DESIGN ADVISORY BOARD Tuesday, October 14, 2014 Conference Room 12, City Hall, Burlington, VT AGENDA

TO: Design Advisory Board
FROM: Scott Gustin *SG*
DATE: October 15, 2014
RE: 15-0451CA/MA, 234-240 College Street

Request: Demolish rear portion of building, construct new five story addition at rear for 9 units. Results in change from 19 residential units to 25 residential units for a net increase of 6 apartments.

C2-01

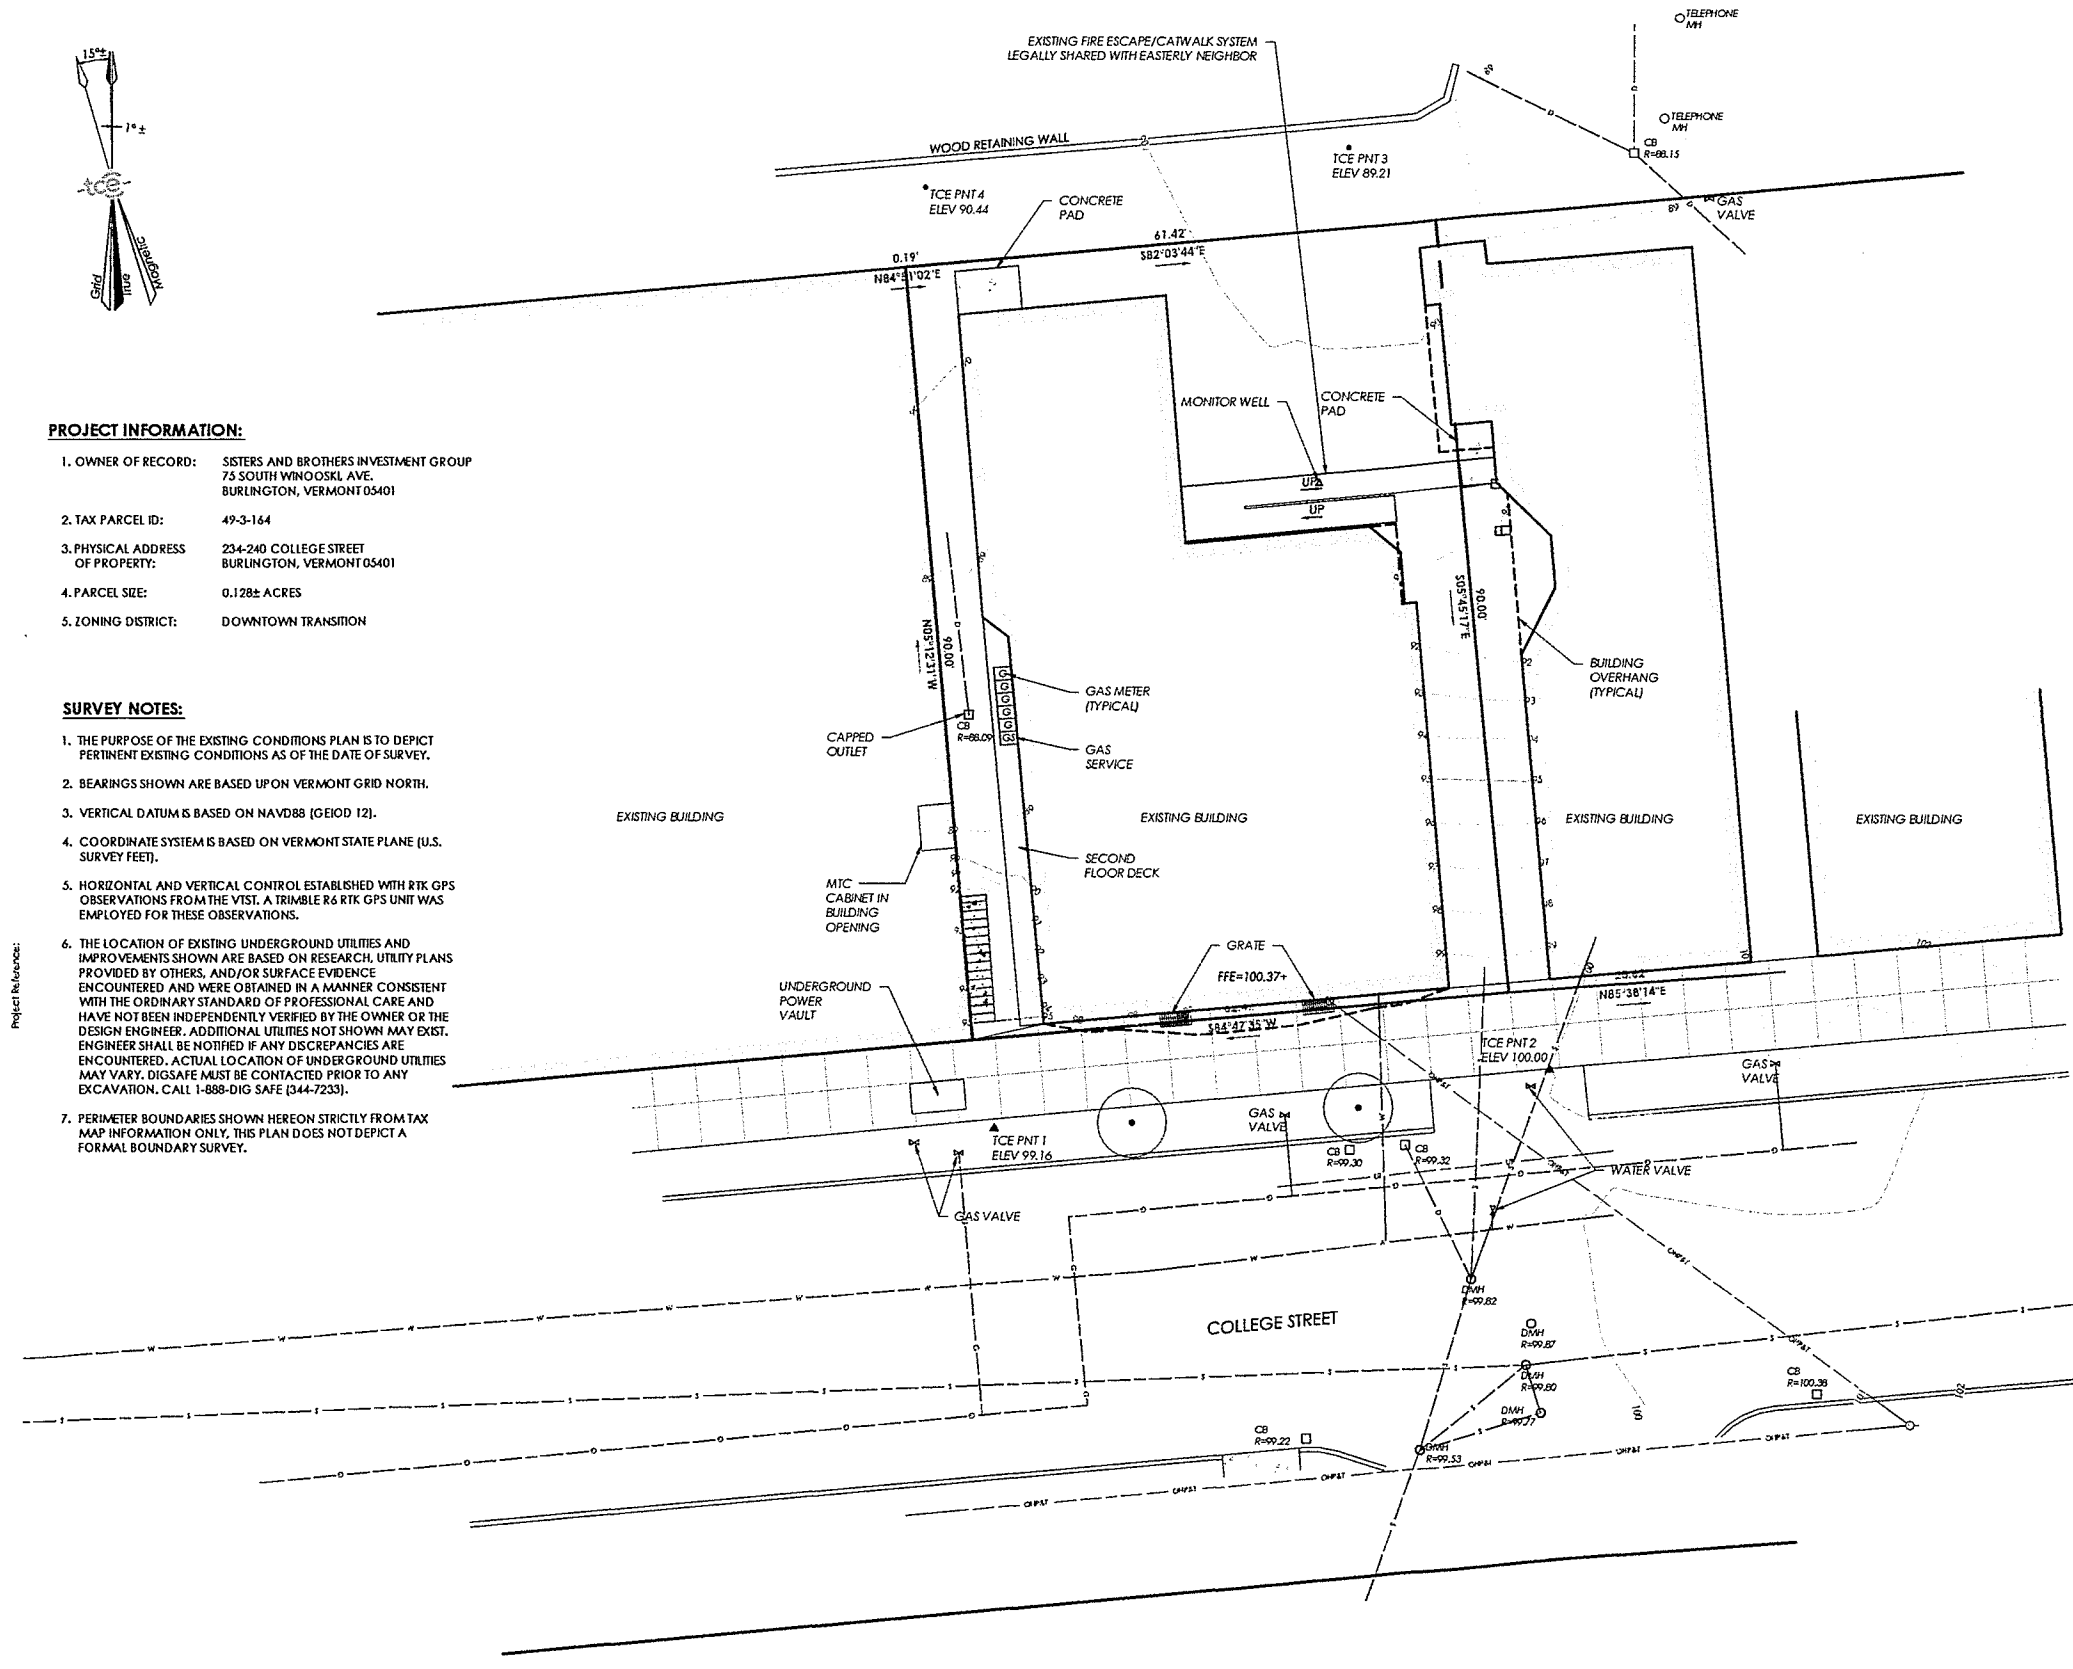
The property is 100% impervious and will remain so. Stormwater presently sheetflows to a catch basin just northeast of the property. The applicant has submitted a stormwater management plan screening form; however, no stormwater improvements are proposed. Leaving stormwater conditions as-is is unacceptable. The city continues to experience combined sewer overflow events. As properties within the combined sewer service area are redeveloped, steps must be taken to capture stormwater onsite and to control its release into the combined sewer system. Chapter 26, the City's *Water, Wastewater, & Pollution Control* ordinance requires doing so. Stormwater improvements are required and are subject to review and approval by the Conservation Board and the Stormwater Administrator.

No new ground-mounted mechanical equipment is proposed. Trash containers will be enclosed within a small closet accessible from the eastern alleyway.

Existing Conditions Plan

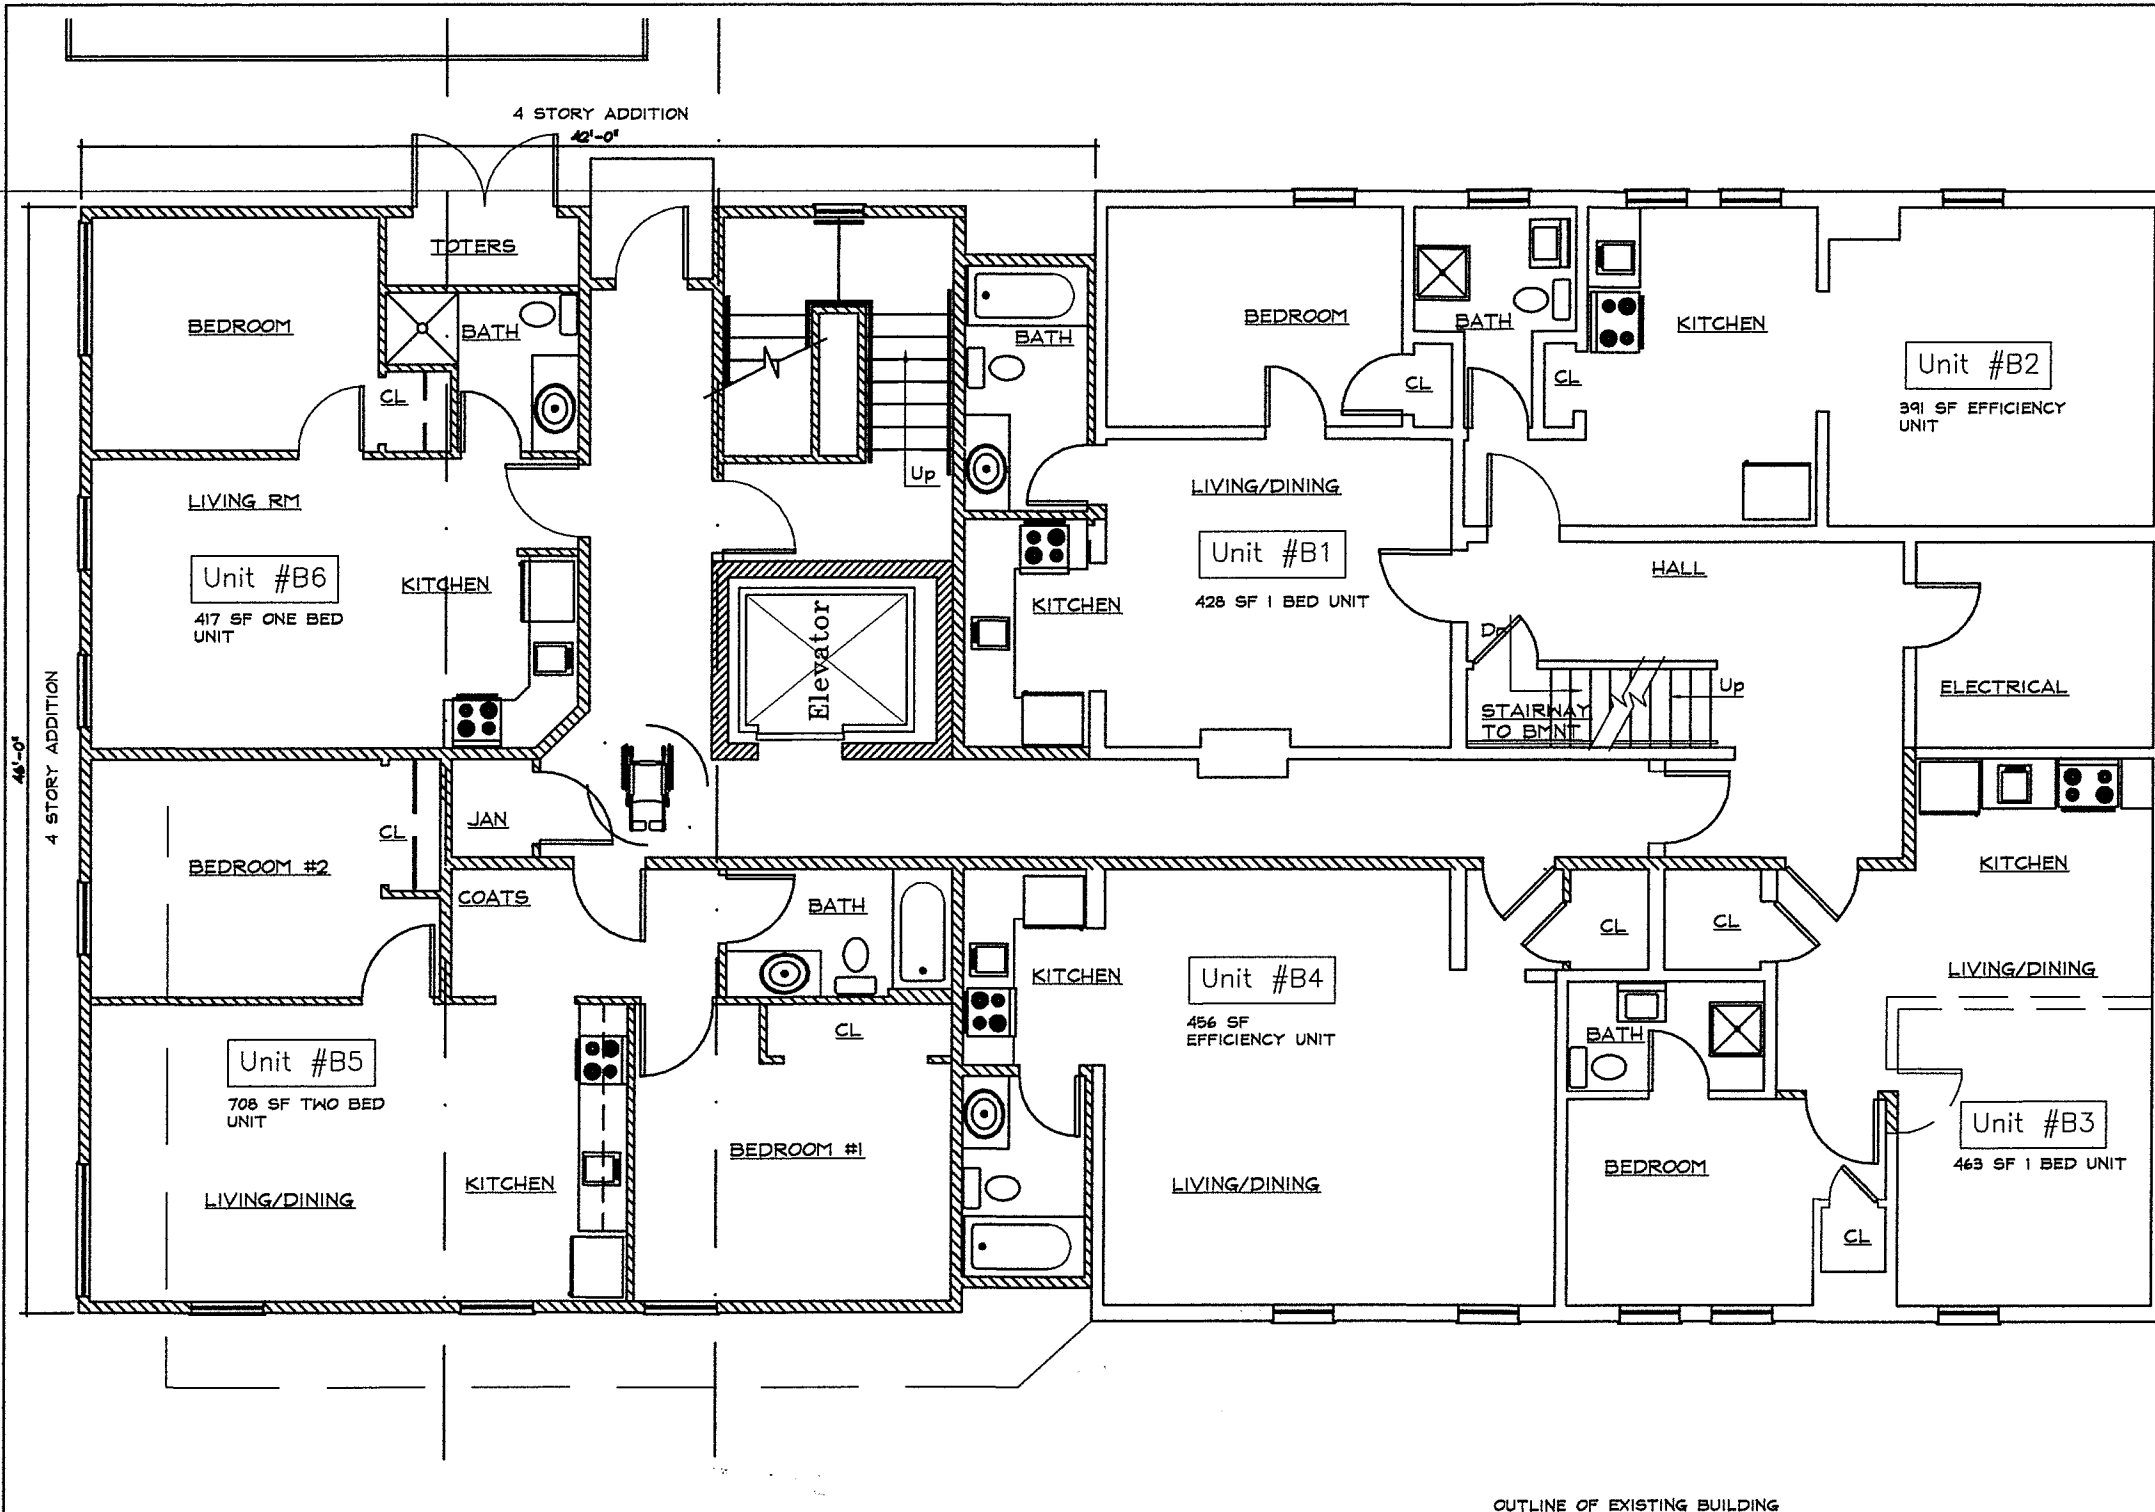
The property can be accessed via College Street with a narrow driveway down to parking behind the existing building. That parking will be eliminated. It is unclear whether the existing curb cut will remain. The site can also be accessed from the rear via alleyway or circulation drive from South Winooski Avenue or South Union Street. No onsite parking is proposed.

The applicant asserts that there is no onsite parking; however, there are vehicles parked behind the existing building, and a "private parking" sign is affixed to the rear fire escape. This small area of parking will be replaced by the proposed rear addition. All parking will be provided for offsite. While Article 8, *Parking*, is not within the purview of the DAB, it bears noting that no offsite parking details have been provided and must be prior to review by the Development Review Board.

- Alleyway should be true pedestrian alley.
- Curb cut onto College Street to be closed allowing a new street parking space.
- Door provided onto alley should have some fenestration, not a security door.
- Indoor bike storage to accommodate access to alleyway.
- Bike storage must be accessible to internal elevator.
